EXISTING CONDITIONS PLAN
77 BROWN AVE, HAMPTON, NH
TAX MAP 287 LOT 3
SCALE:1"=10'   SEPT 27, 2017
STOCKTON SERVICES, HAMPTON, NH

Re: 77 Brown plans
1 message

—EXISTING—
PLAN OF LAND
FOR
KEVIN V. & KRISTINE SHEEHAN
77 BROWN AVENUE
HAMPTON N.H.

FRONT ELEVATION

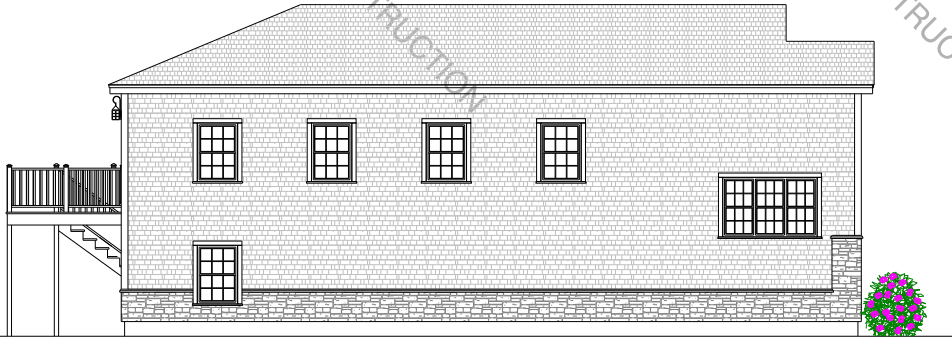
placement of your proposal is attached. My initial reaction.......
1. your elevation drawings do not match the plan information, notably the back deck and stairs.

4. Your drawings do not reflect the fact that your slab is going to be 3' above existing grade.
5. I am concerned that the building design does not take into account that your slab is going to be 3' above grade.
I am neither qualified nor willing to try to develop a construction/grading plan for this proposal. Unless you have an engineer who is willing to assume responsibility for it, I have to stick with my abdication.
I am way underpaid for my time on this (with more hours today) and don't want to spend any more, please.
I'm sorry but I am not willing to put my stamp on a proposal that I can't support.
Good luck.
Tocky
